Staff Report

To: Historic Landmark Commission

Re: Petition PLNHLC2017-00560 for New Construction at 1117 E South Temple Street
Petition PLNHLC2017-00763 for Special Exceptions at 1117 E South Temple Street

NEW CONSTRUCTION & SPECIAL EXCEPTION IN HISTORIC DISTRICT

SHEET TITLE
**SIGNAGE, WINDOW
TYPES, MATERIALS &
LIGHT FIXTURES**

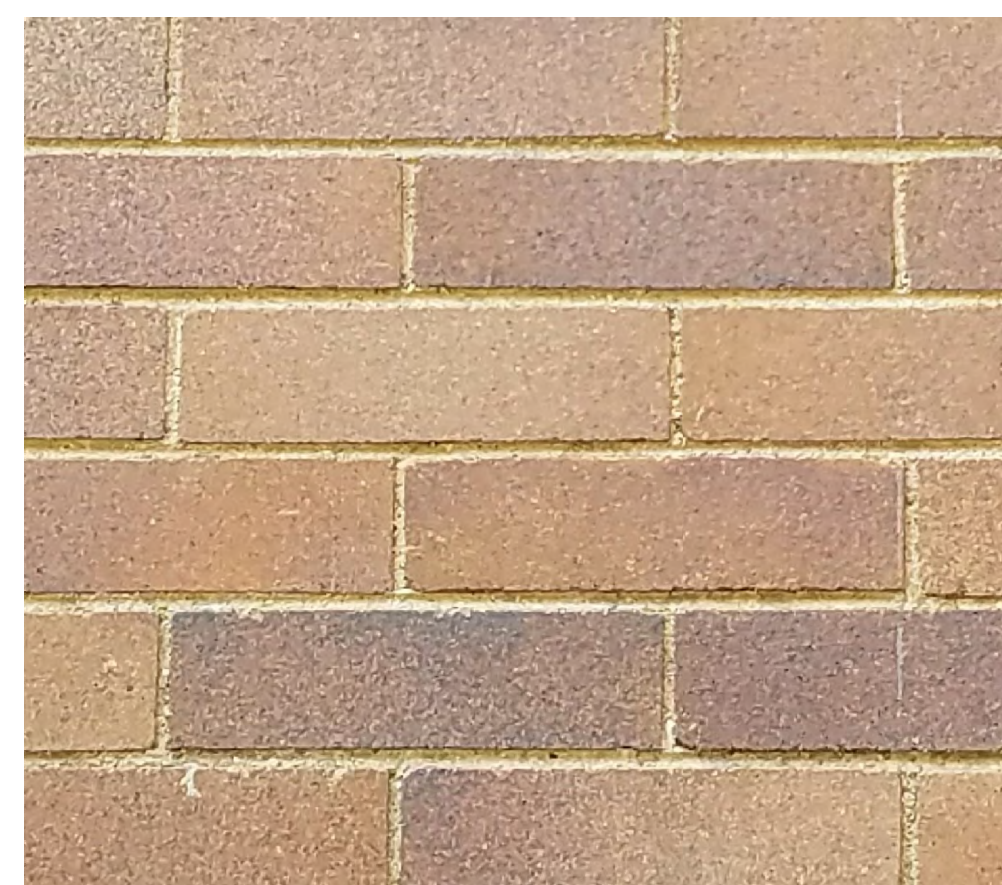
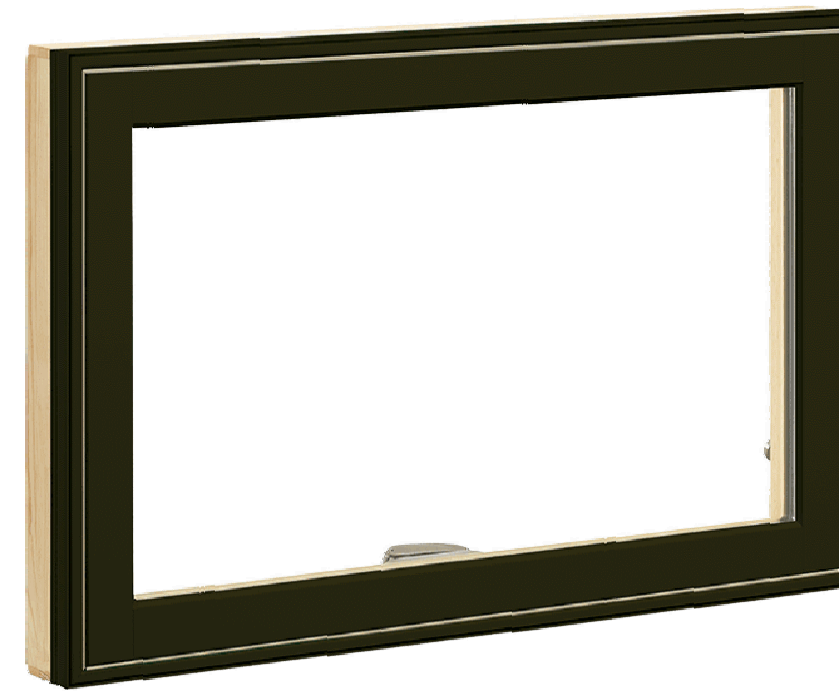
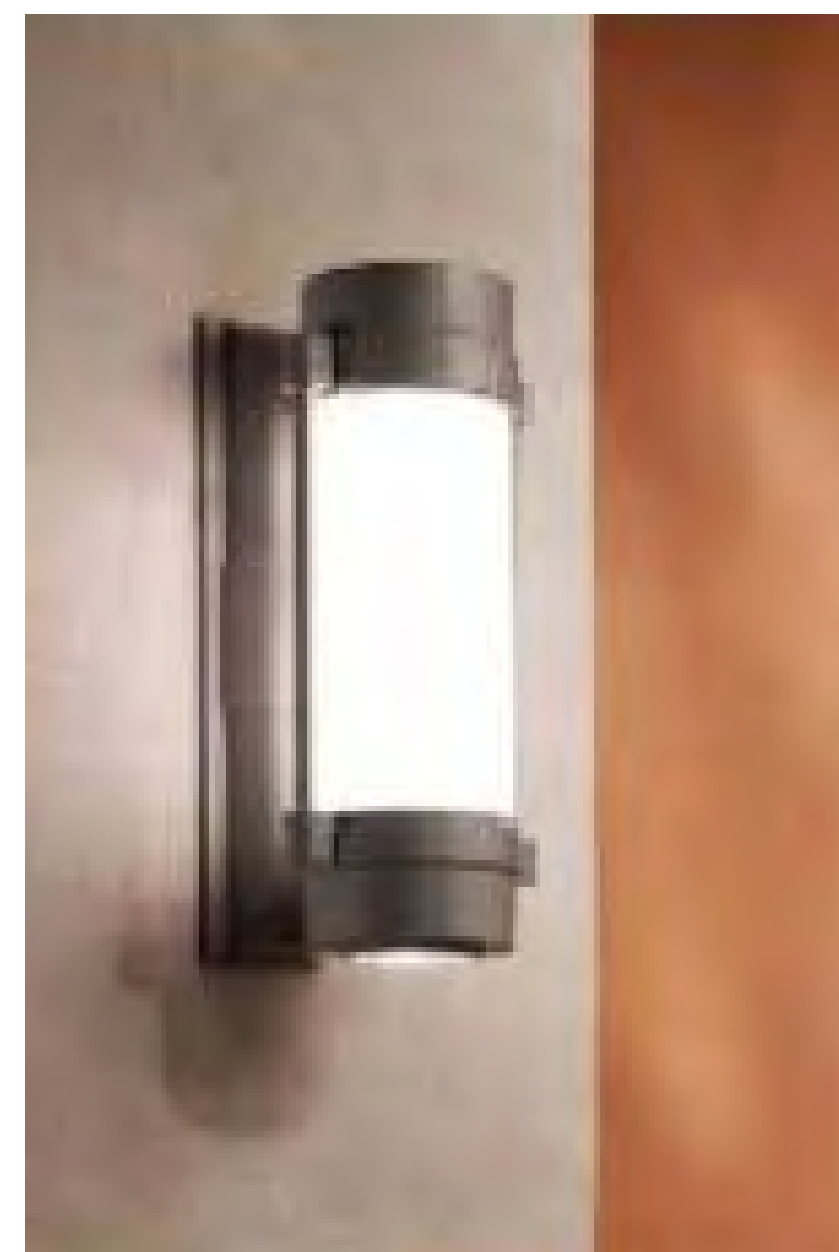
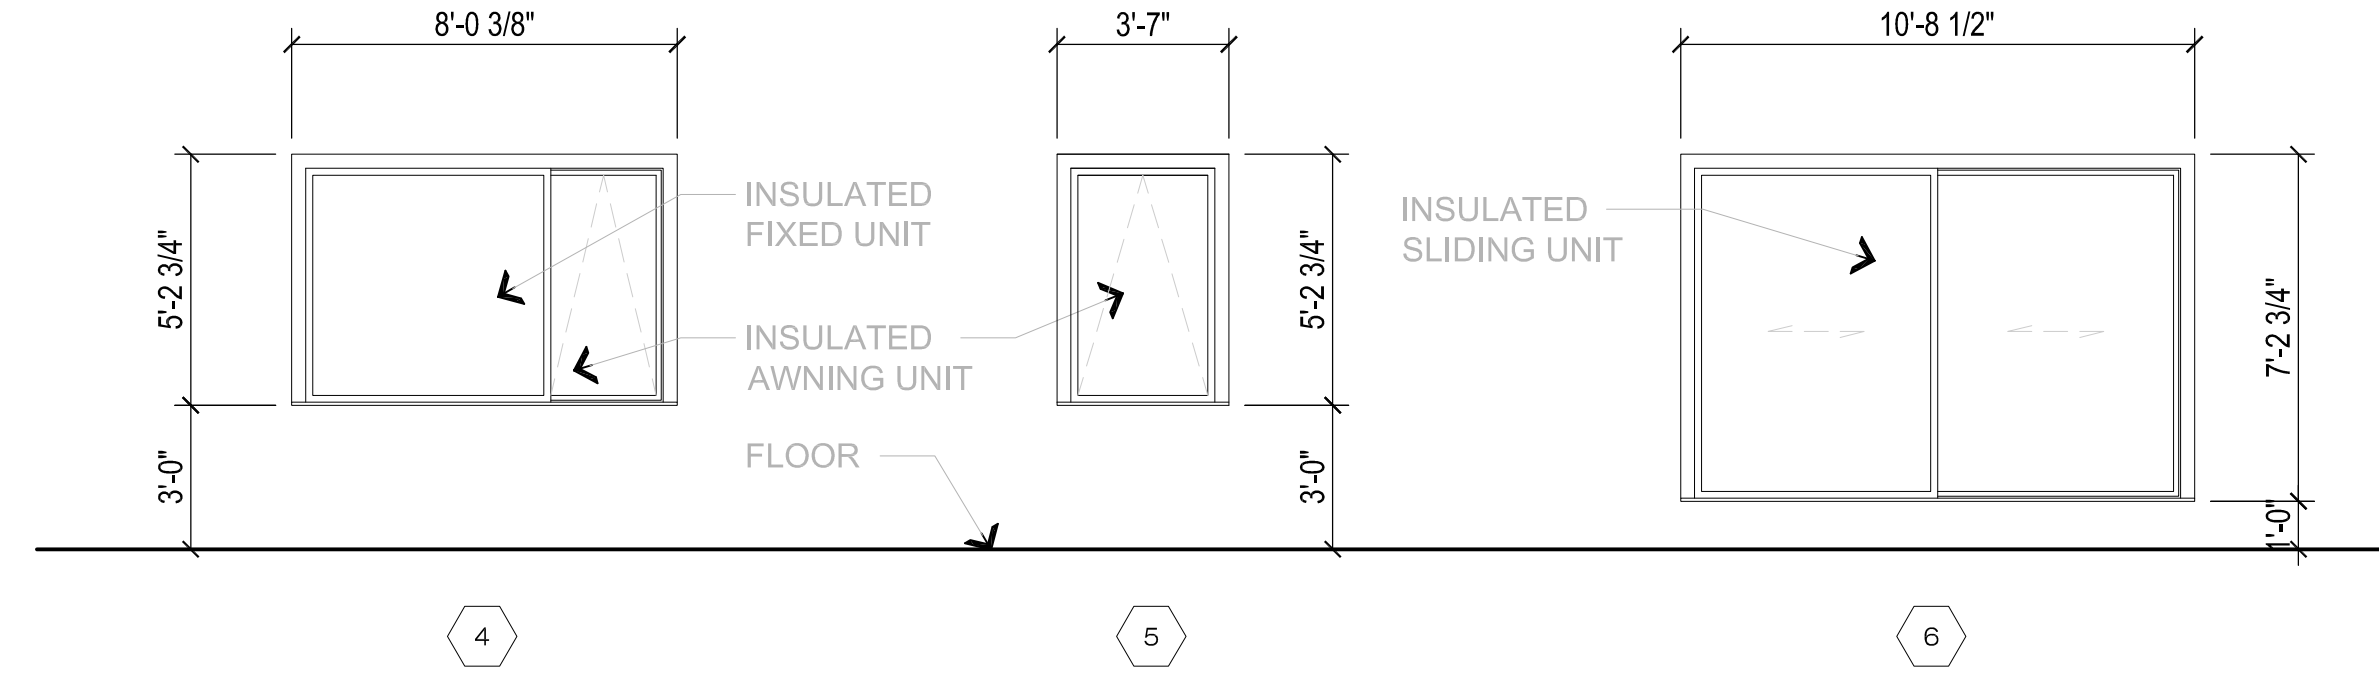
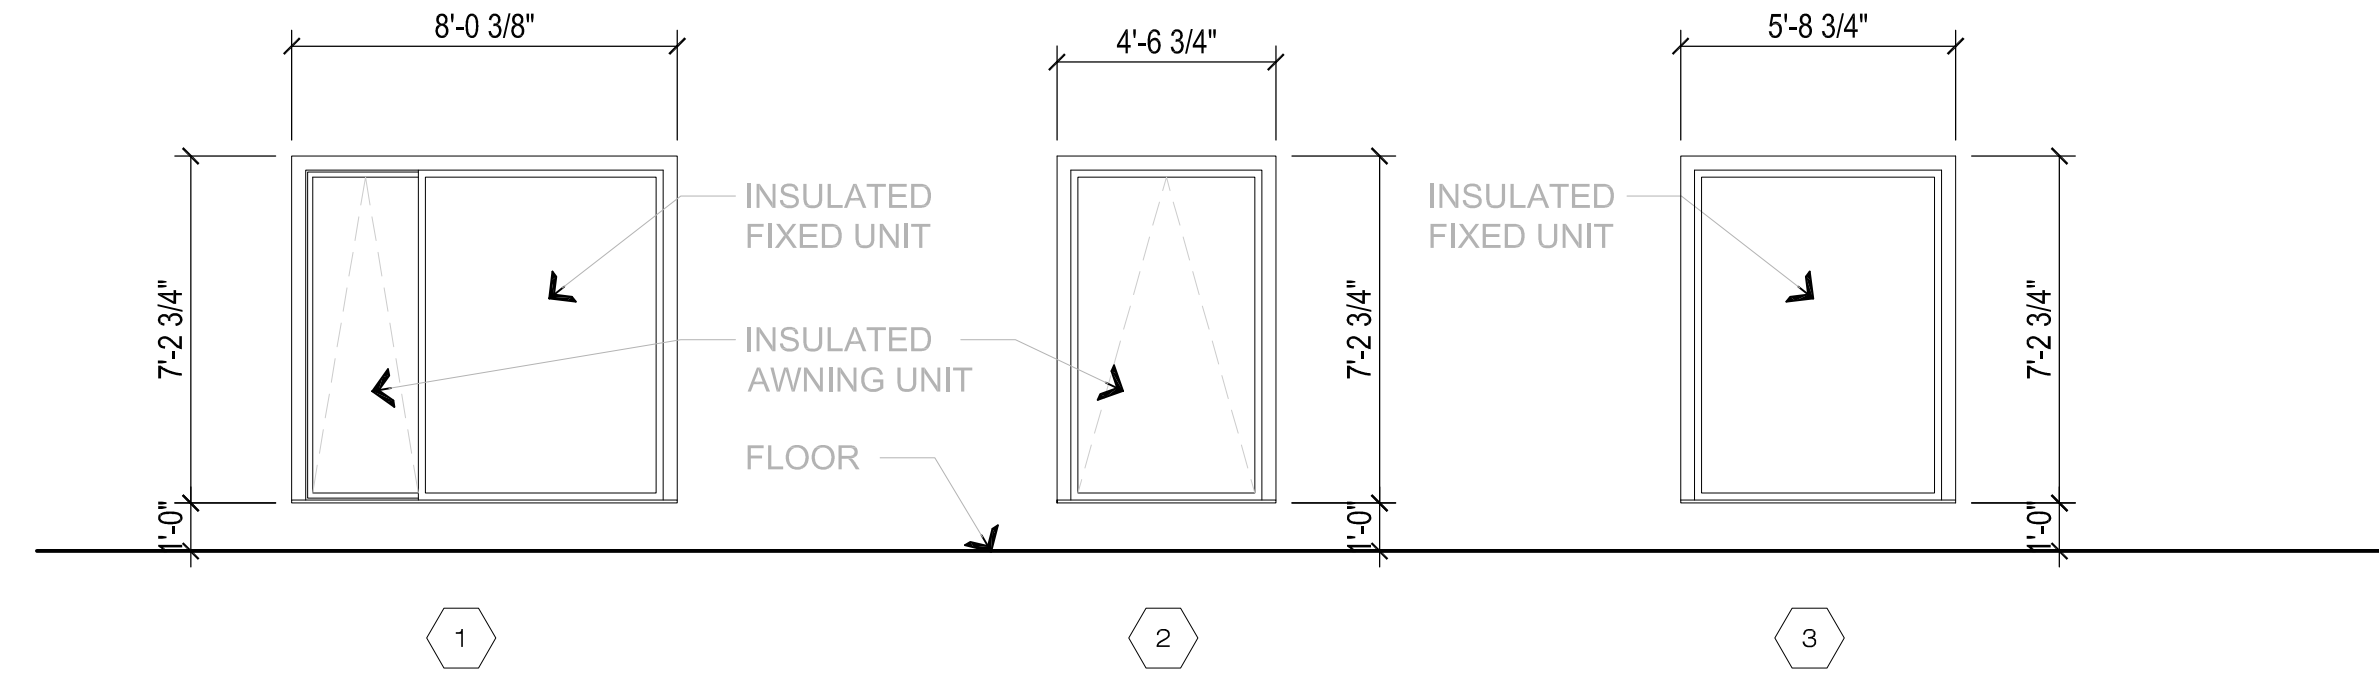
Issue 5 – Building Lighting. “Exterior lighting is an important architectural element of any building. Exterior light fixtures should complement building architecture as well as the historic district. While lighting should accent architectural and landscape features, as well as enhance security, lighting should be carefully controlled to avoid light pollution and glare. Staff recommends the architect submit for future review a lighting plan that includes specifications for all exterior fixtures.” **(September 7, 2017 Historic Landmark Commission Memorandum)**

Issue 8 – Fence Design. “Submitted plans do not include a fence plan. If the applicant intends to have decorative, privacy, or security fencing within or along any yard, a complete fence plan with location, height, and materials must be submitted for review. If fencing is to be installed, staff encourages the applicant to coordinate planning and construction with abutting property owners.” (September 7, 2017 Historic Landmark Commission Memorandum)

Response. Applicant included proposed light fixtures in Attachment J – Building Materials. However, the City has not received a lighting plan that details the location of all fixtures.

Response. The applicant included fence materials in Attachment J – Building Materials, which appear to be appropriate for the South Temple Historic District.
